# HARTING Product Change Notification

Business Unit: Electric PCN/16/016/C+N

Title: Design change Han-Modular® module adapter - External

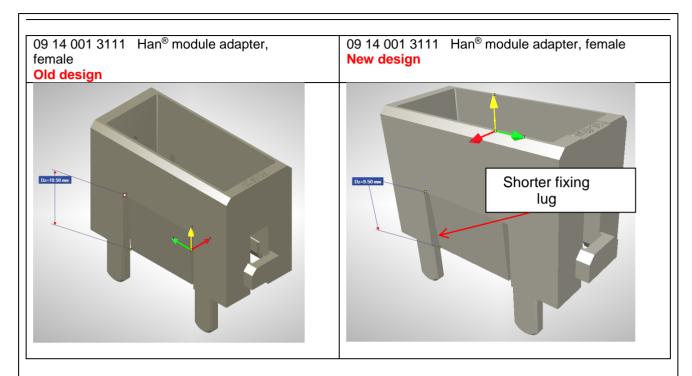
#### 2. Description of changes / news:

**Please note:** Color / appearance of the adapter will not be affected by this design change, different display in the pictures above results from variably CAD data.

09 14 001 3011 – revision level changed from 01 to 02 09 14 001 3111 – revision level changed from 01 to 02
